Minutes
of
92nd PCC Meeting

MINUTES OF 92ND PROTECTION SUB-COMMITTEE MEETING HELD ON 22.07.2020 AT 10:30 HOURS

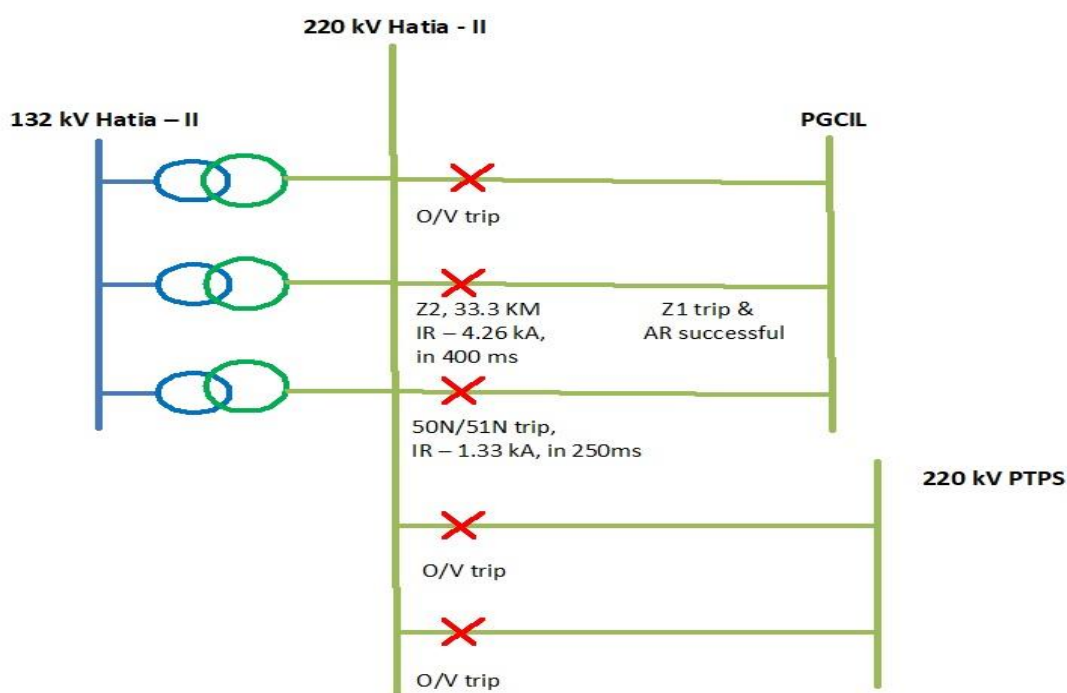
JUSNL informed that 132kV Manoharpur-Goelkhera line was tripped from Goelkhara end on overcurrent protection. JUSNL further informed that DR of Goelkhara end was not received as it was overwritten.

JUSNL added that zone 4 time setting of 220 kV Chaibasa(JUSNL)- Chaibasa (PG) line 1 at Chaibasa(JUSNL) was revised from 300 ms to 500 ms.

PCC observed that the fault in 220 kV Chaibasa – Ramchandrapur circuit 1 got cleared from 132kV transmission line protection which was the only source from 132kV side. PCC opined that 220/132 kV ATRs backup protection should clear the fault in this case. PCC explained that transformers would get damaged due to continuous fault feeding due to delay in protection system operation from 132 kV Side for a fault in 220 kV system.

PCC advised JUSNL to take the following corrective actions:

- CB of Chaibasa(JUSNL) end of 220 kV Chaibasa – Ramchandrapur circuit 1 to be tested
- Protection system of 220/132 kV ATRs to be tested along with healthiness of DC and the respective CT, PT connections to be checked

ITEM NO. B.7: Disturbance at 220 k V Darbhanga S/S on 10.06.2020 at 10:54 hrs.

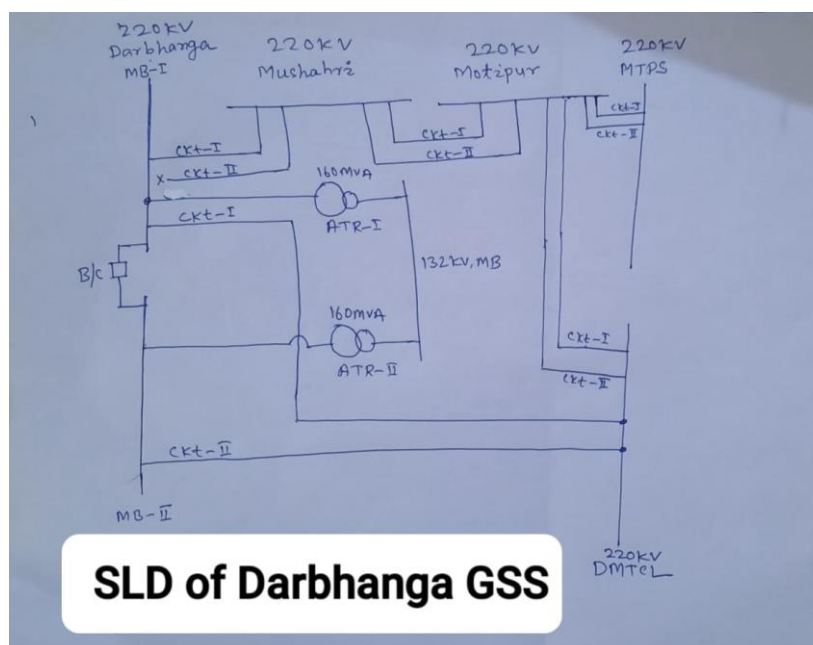
BSPTCL explained that fault was in 220 k V Darbhanga(DMTCL) – Motipur -1 line, the line got tripped in zone 1 and the auto-reclose was successful at Motipur end.

DMTCL informed that auto-reclose was unsuccessful at Darbhanga(DMTCL) end.

BSPTCL informed that 220 kV Darbhanga (DMTCL)-Darbhanga (BSPTCL) circuit 2 got tripped from BSPTCL end on directional earth fault. Thereafter LBB protection at Darbhanga (BSPTCL) was operated due to loose connection and tripped 160 MVA ATR-2 which was connected to Bus II. As a result, 160 MVA ATR-I and 220 kV Darbhanga (BSPTCL) – Mushahari – 1 also got tripped due to overload.

ERLDC pointed out that when system remains on both buses (MB-1 & MB-2) through bus coupler then the current values are unsymmetrical resulting in abnormal neutral current. But when the system is put on the single bus the currents are in symmetrical.

After detailed deliberation, PCC advised DMTCL to check the reason for non-operation of auto-reclose of 220 kV Darbhanga(DMTCL) – Motipur -1 line from DMTCL end.

PCC advised BSPTCL to take the following corrective actions:

- Test the breakers at 220/132 KV GSS Darbhanga (BSPTCL)
- Test the healthiness of LBB protection at Darbhanga (BSPTCL)
- Find out the reason for occurrence of unsymmetrical current at Darbhanga (BSPTCL) and resolve the issue.

Figure 1: List of the transmission lines which tripped more than two times during the month of May 2020

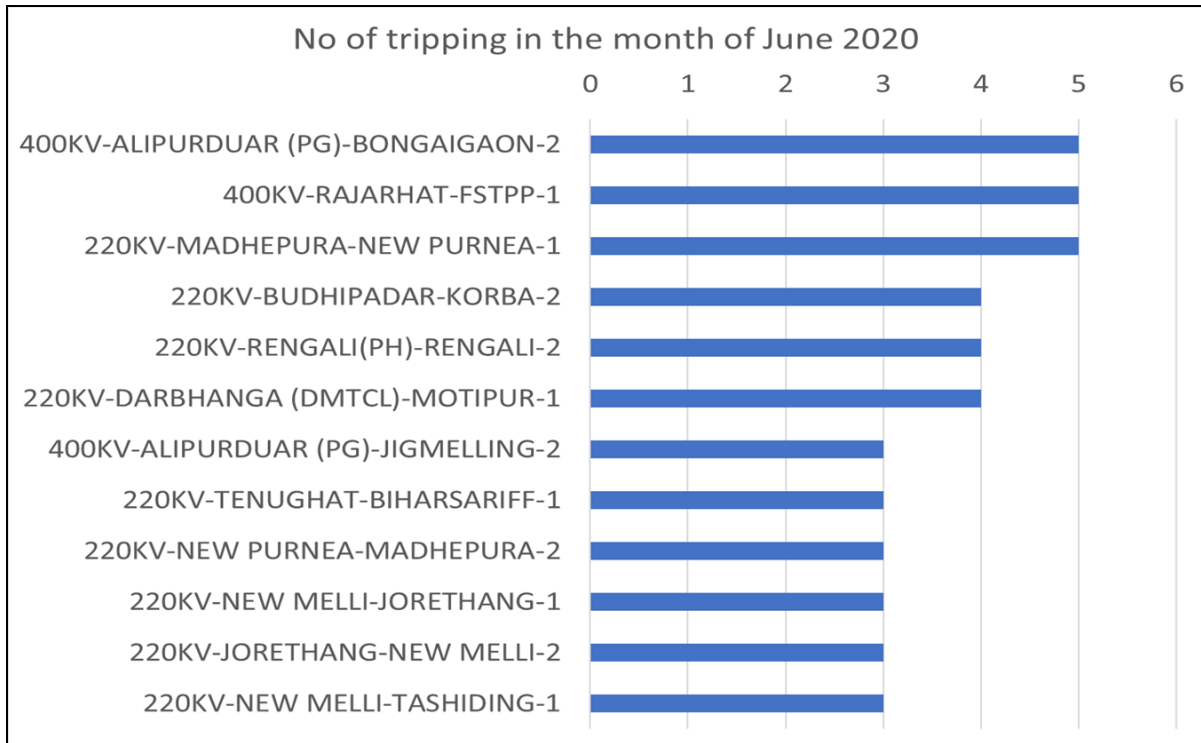
As shown in Figure 1, there are 12 transmission lines having voltage level 220 kV and above and which tripped more than two times in the month of June 2020. Around 11 and 14 transmission lines having voltage level 220 kV and above tripped more than two times in the month of April and May 2020 respectively. Growing number of repeated tripping of transmission lines is putting grid in grid in vulnerable condition. Repeated tripping of some transmission lines resulted repeated grid disturbances and grid incidents along with load and generation loss.

B7. GD at Darbhanga on 10-06-2020

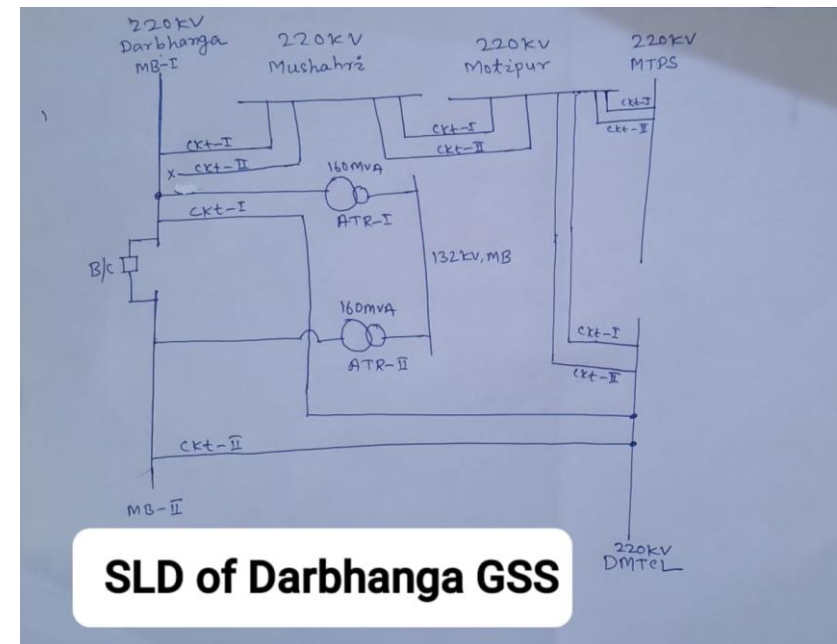
- BSPTCL report
 - At 10:54 Hrs 220 kV Motipur-DMTCL ckt-1 got tripped from both ends.
 - At the same time Darbhanga (BSPTCL)-DMTCL ckt-2 got tripped on Aided D.E.F.
 - Darbhanga (BSPTCL)-DMTCL ckt-1 was intact and not tripped.
 - At the same time 160 MVA ATR-2 got tripped on Earth Fault. DR could not be fetched from Relay resulting tripping of 160 MVA ATR-1 on overload.
 - Simultaneously Darbhanga (BSPTCL)-Mushahari ckt-1 also got tripped from Darbhanga (BSPTCL) end. (DR uploaded)
